NL-08-0979

**Vogtle Electric Generating Plant
License Renewal – Revised RAI Responses**

Revised Responses to RAIs 2.3.3.19-1, 3.3-1 & 3.4-1, and 4.3-04

Figure 1: Design Transient for Fast Transient

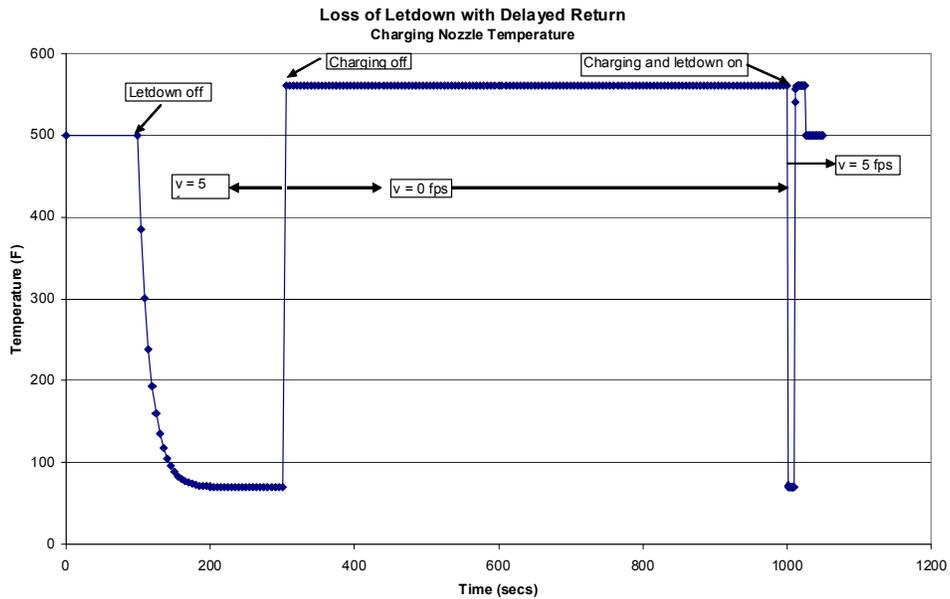
- a. Figure 1 and Figure 2, the temperature transient curves for the charging nozzle, are missing from the response. Please provide them.
- b. The locations for the charging nozzle and the surge line hot leg nozzle are at the safe-end region. Confirm the critical fatigue locations are at the safe-end region and provide supporting analysis results.

- a. When the attachment to NL-08-0228 was converted to pdf format, the page with Figures 1 and 2 was inadvertently left out. They are included below.
